Access Compliance Report

Public Rights-of-Way

(Curb Ramps)

Intersection ID: 23386	Main Street: ALEXANDER_RD	Cross Street: BENNING_WOOD_DR	Location:	N
ADA ID: D750BD351A8A	Ramp Type: Directional1	Initial Pass/Fail: Pass	Overall Compliance: No	Severity Score: 7.5
Codes/Mitigation Info/Possible Solution		Field Measurements/Component Compliance

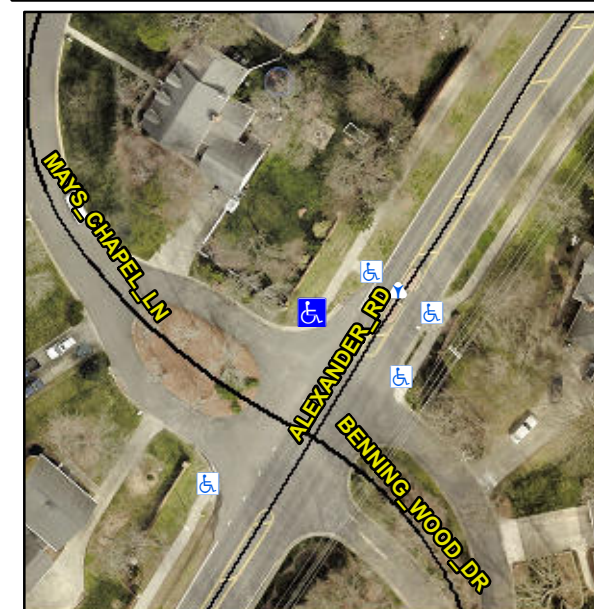
Surveyor Notes:

N/A

PROW/ADA:

R304.5.3, R305.1.4, R304.5.4

Possible Solutions:

**Remove & Replace Entire Ramp.
Remove & Replace Gutter.**
